## PLAT COMMITTEE

<b>Case Number:</b>	2023-PLT-086
<b>Property Address:</b>	4140 North High School Road ( <i>Approximate Address</i> )
<b>Location:</b>	Pike Township, Council District # 10
<b>Petitioner:</b>	Circle City Property Group, LLC, by William T. Niemeier
<b>Zoning:</b>	C-3
<b>Request:</b>	Approval of a Subdivision Plat, to be known as Circle City Addition, dividing 3.22 acres into two lots.
<b>Waiver Requested:</b>	None
<b>Current Land Use:</b>	Commercial
<b>Staff Reviewer:</b>	Allison Richardson, Senior Planner

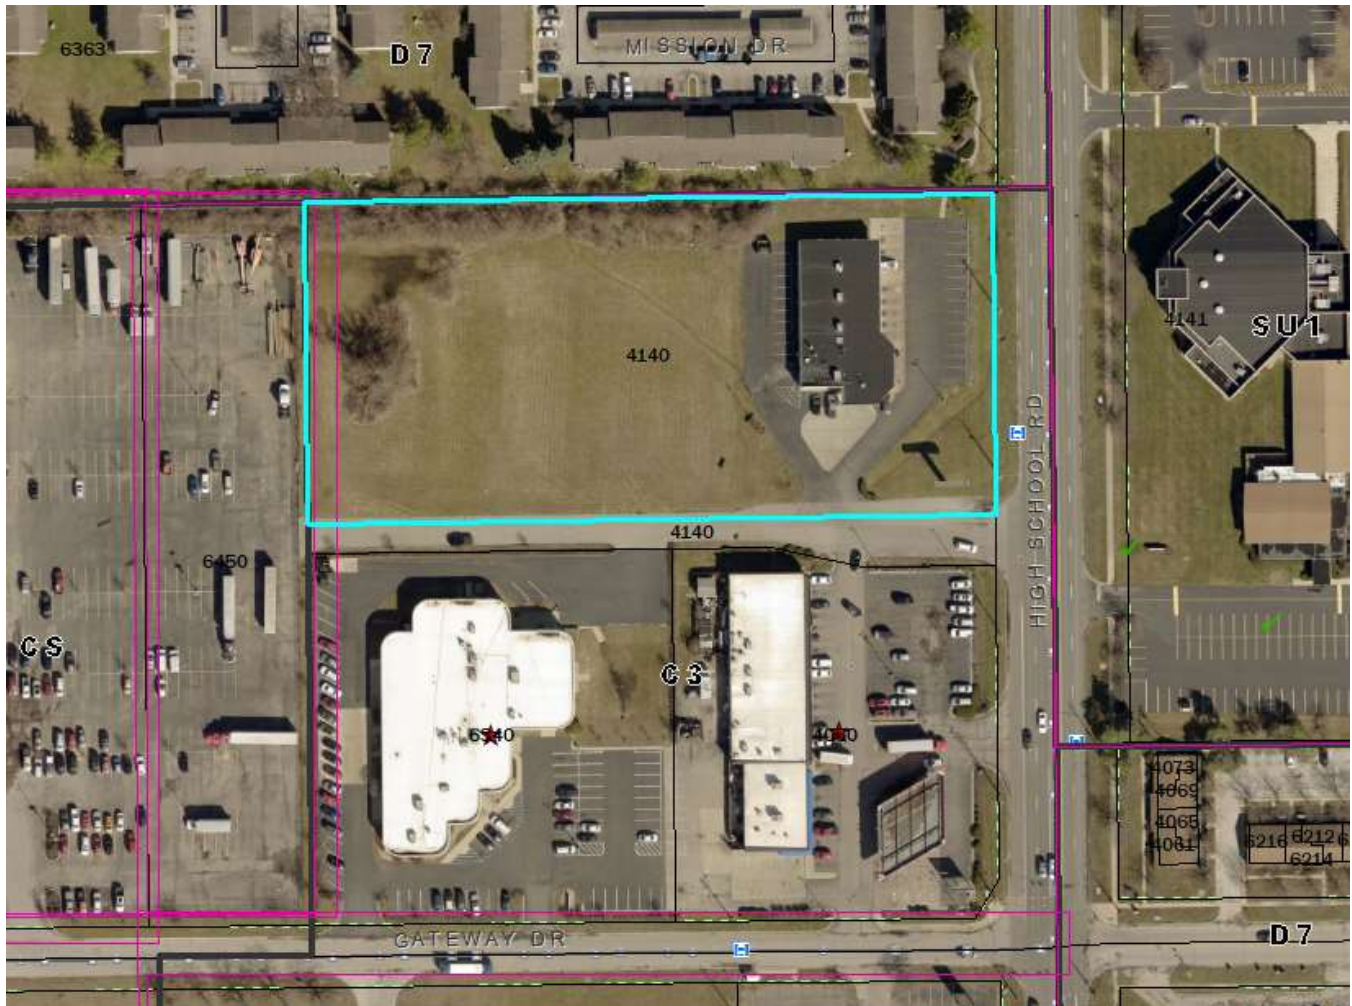
Lot One would front on High School Road to the east. Lot Two would have access to High School Road via the easement to the south noted on the survey. No new streets are proposed as part of this petition.
